Cassington Parish Council,

Botley West Solar Farm – Application for an Order granting Development Consent

Cassington Parish Council Responses to Submissions in Response to
the Secretary of States Consultation 1 Letter issued 14th April, 2026
(original) and 20th April, 2026 (Amended).

Figure 1. Proposed scaling back of the Botley West proposed solar arrays north of Cassington and Worton. Areas in red hatch are where solar arrays from the proposal are removed.

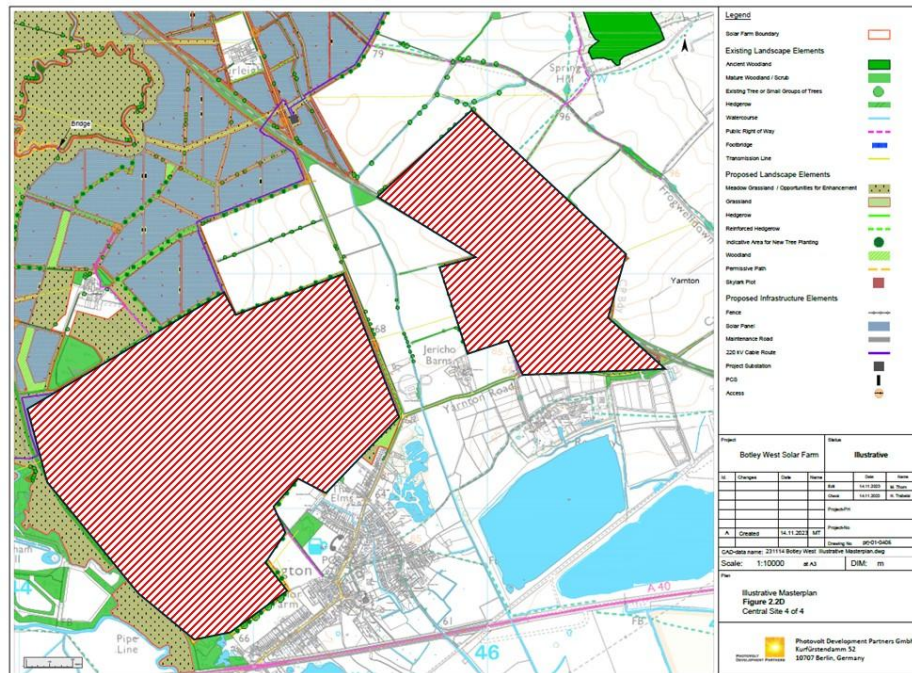
Cassington Parish Council are therefore proposing that either the Botley West proposal is rejected which remains both the Parish Council's and resident's favoured option, or it is scaled back from the north of the village to the summit of the hill contours that lie to the north of the village. A rough sketch of what this would look like is indicated in Figure 1 below.

This proposal has the advantage of moving the entire scheme back from Cassington village where we believe that it is far too close to dwellings in the village. This will help to preserve amenity of at least some of the public rights of way from Cassington and Worton. It also avoids issues around the potential alterations to local temperature that may occur as a result of conversion of solar energy to heat by the vast array of panels across the landscape. It also preserves some of the greenbelt and farmland that would otherwise be lost.
